Traffic Engineering Report

Proposed Mixed-Use Development at 11-23 MacArthur Avenue, Hamilton

Brookfield Portside East Pty Ltd

Appendix A TTM Response to EDQ's RFI

Figure 4 - Ground floor plan extract - showing indicative applied graphic pattern to pavement

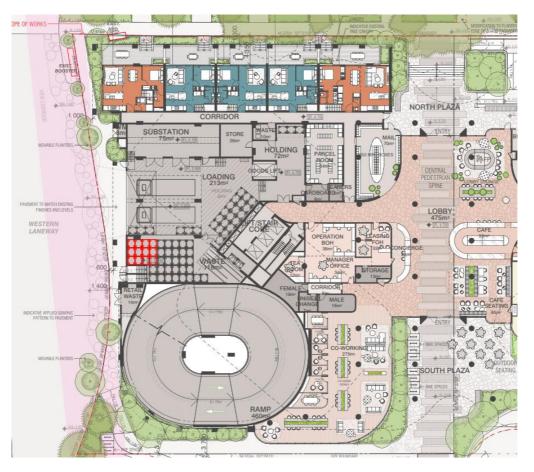
The ability to enhance/change the laneway to the west of the main site is limited by tenure considerations as well as servicing constraints, however the amended plans include a proposed applied graphic pattern to the pavement to provide greater legibility and create a sense of a shared-use space, as shown on the following render and ground floor plan extract –

EDQ are reminded that a number of changes were made during the pre-application stage to ensure that the laneway as a shared-use space could be adequately overlooked to create a safe pedestrian environment. Units sleeve the car park at western elevation of the building at L2 to L4 and there are also opportunities for overlooking from Flare on the western side of the laneway as well as from Gallery House to the south. The apartments on the northern side of Macarthur Avenue also have a direct line of site to the laneway.

FIGURE 1 - B99 CIRCULATION AT SET DOWN AND PORTAL RAMP

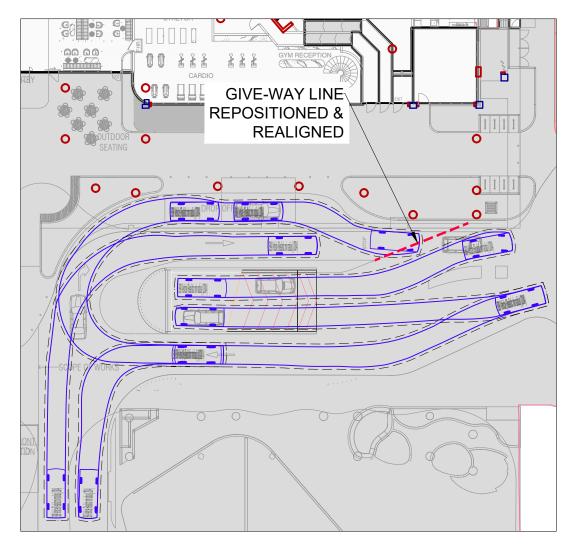
In order to mitigate conflict at the exit from the set down area and at the interface between the portal ramp and the one-way circulation road (facilitating vehicular egress from the basement and podium parking areas within the Rivello Building and the ground level parking area within Gallery House) modifications are proposed to the existing line marking to improve intervisibility between vehicles. Furthermore, the one-way circulation road adjacent to the set down area has been widened to allow for improved circulationby the nominated design vehicles.

In order to mitigate conflict at the exit from the set down area and at the interface between the portal ramp and the one-way circulation road (facilitating vehicular egress from the basement and podium parking areas within the Rivello Building and the ground level parking area within Gallery House) modifications are proposed to the existing line marking to improve intervisibility between vehicles.

RENT DEVELOPMENT	21BRT0771	A3
	DRAWING NUMBER 21BRT0771-03	
G SPACE MANOEUVRING AT	26 Jul 2023	3 OF 3

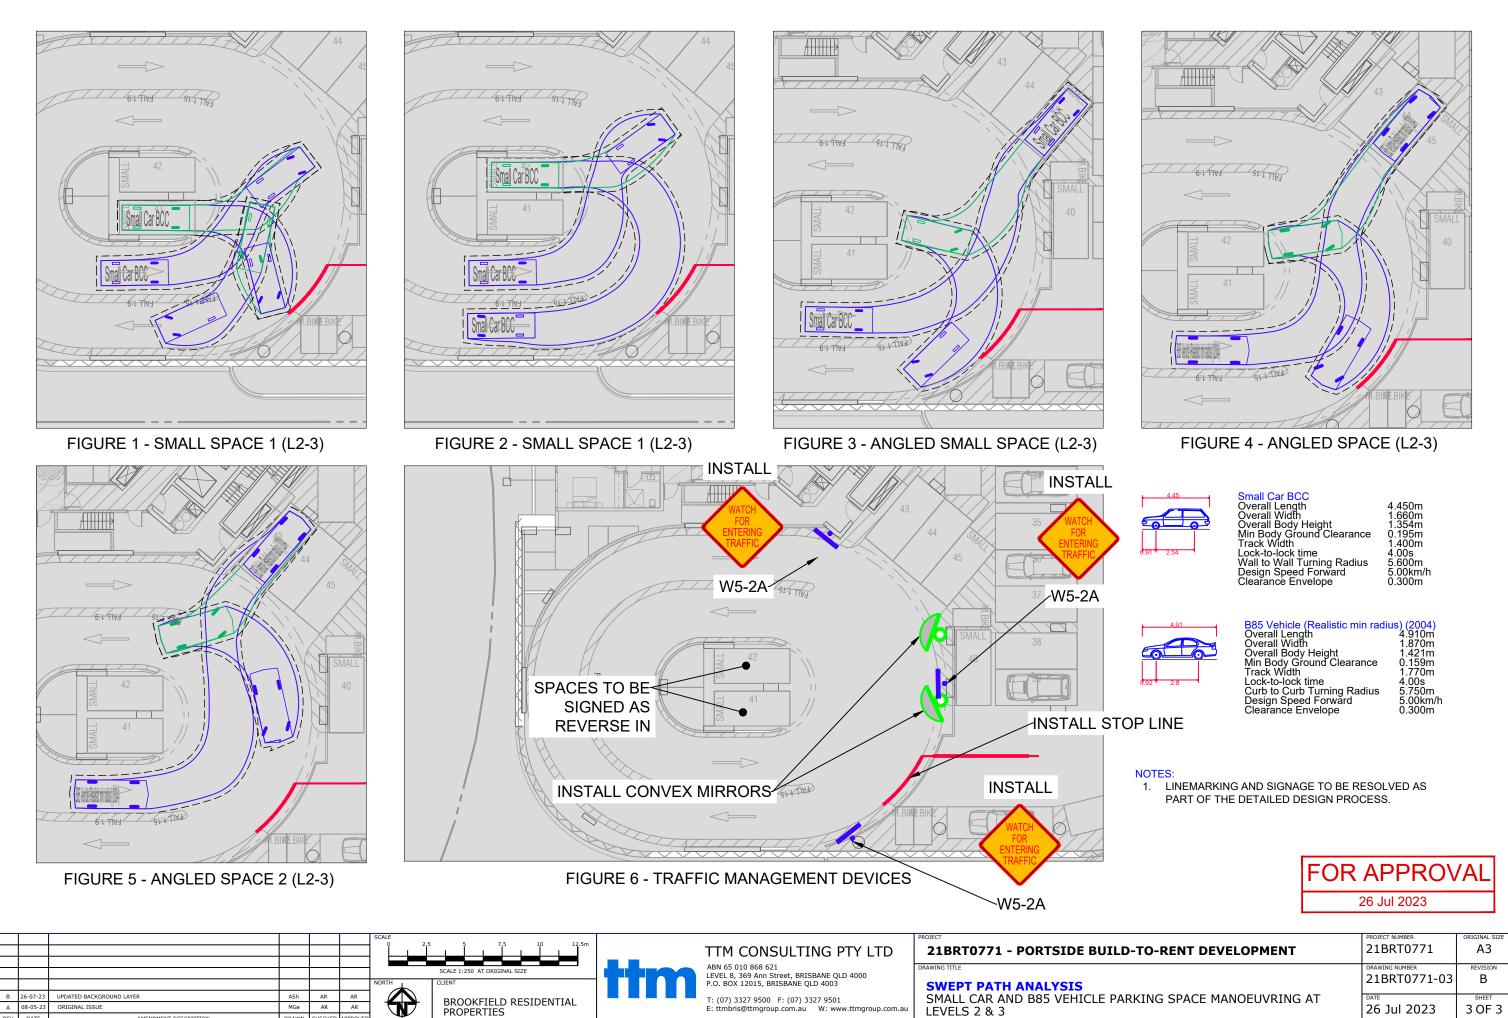
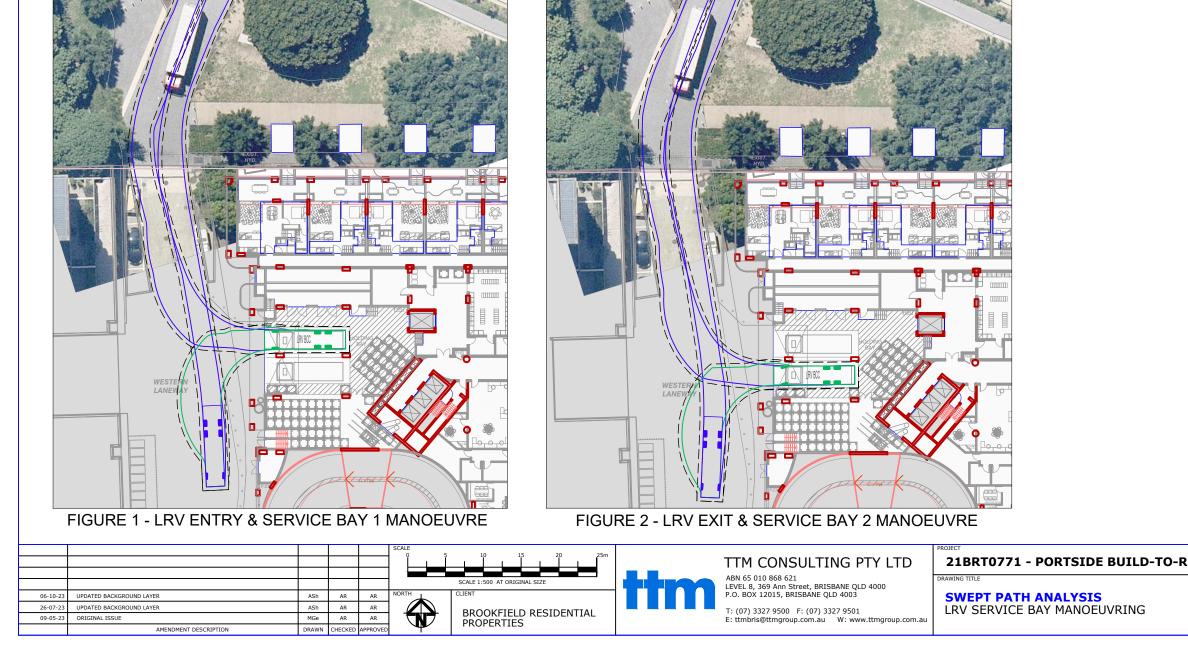
Demonstrate on plans/in TTM Report how the carparking spaces provided within the ramp can be safely accessed and can meet the appropriate standards.

Typical manoeuvring to/from the parking spaces provided adjacent to the circulation road/ramp/aisle at podium levels 2 and 3 is demonstrated (using Autotrack software) on Drawing No. 21BRT0771-03 (3 of 3) included as **Attachment 2**. Given that vehicular speed within the parking areas will be restricted to 10kph it is anticipated that any potential road safety issues due to conflict between circulating traffic and vehicles manoeuvring to/from these parking spaces will be negligible. The level of circulating traffic at this location at podium level 2 is estimated to be in the order of 27vph (or 1 vehicle every 2-3 minutes) whereas at podium level 3 it is estimated to be 14vph (or 1 vehicle every 4-5 minutes). It should be noted that these estimates for circulating traffic at podium levels 2 and 3 are based on the number of parking spaces provided at the upper podium levels (i.e. 180 parking spaces above podium level 2 and 91 parking spaces above podium level 3) and the application of a traffic generation rate of 0.15vph/space in the weekday AM peak-hour as sourced from the Transport Maritime & Roads Service (TMRS) Guide to Traffic Generating Developments – Updated Traffic Surveys.

Based on the estimated levels of circulating traffic at these locations at podium levels 2 and 3, it is anticipated that potential for conflict will be minimal. Whilst the gradients provided on the inside and outside of the circulation ramp at these locations, which vary between 1:7 (14.3%) and 1:11 (9.1%), are quite gentle when compared to the maximum gradient of 1:6 (16.7%) permitted under BCC's TAPS PSP, as shown on Drawing No. 21BRT0771-03 (3 of 3) to enhance driver to driver visibility it is intended that the parking spaces provided on the inside of the circulation road/ramp/aisle will be signed as "REVERSE-IN" only. As a supplementary measure it is intended that "WATCH FOR TRAFFIC ENTERING" signage and convex mirrors will be installed.
